STAFF REPORT

SUBJECT: OCP and Zoning Amendment for Lot A and C Gibsons Way

REPORT FOR INFORMATION AND DECISION ON NEXT STEPS

Figure 4: Lot A and C Gibsons Way development proposal

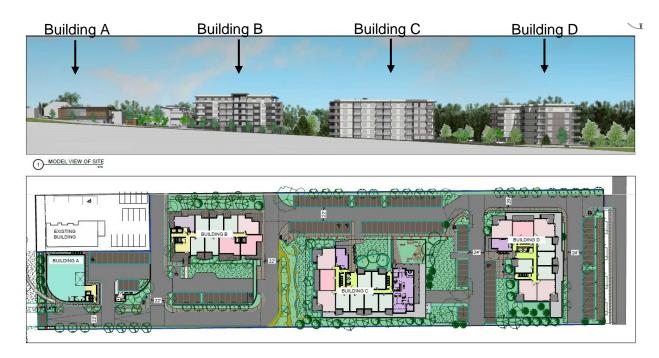
Figure 4 shows the building heights in relation to the slope of the lot. When looking at the site from Gibsons Way, the tops of the buildings will be slightly taller than the 2-storey commercial building.

Figure 10: Landscape Plan showing Building A and Building B

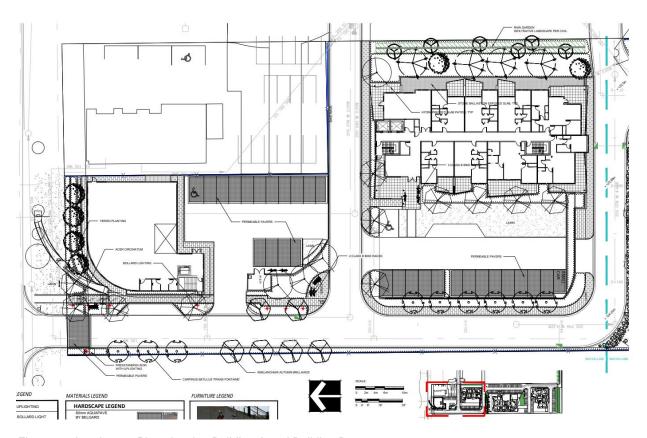
When looking at the Landscape Plan, as shown in Figure 9, Building B (residential) is off set to the east from Building A (commercial), but is adjacent to the 101 Brewhouse and Distillery parking lot and separated with 22 ft (6.7 m wide circulation road).

Along the north side of the building, a permeable paved pathway and 4 mature trees with shrubs beneath are proposed. Currently there is no landscape buffer along the south side of the parking lots for the proposed new building and the 101. Staff suggest that additional landscaping may be needed to provide some screening of the parking from the residential areas.

B) This option requests Staff to draft the OCP and Zoning Amendment but includes a request for some minor changes to the proposal – examples of minor changes/revisions could be to add additional landscaping to buffer the existing 101 Brewhouse parking lot from Building B, or add an outdoor amenity space for residents.
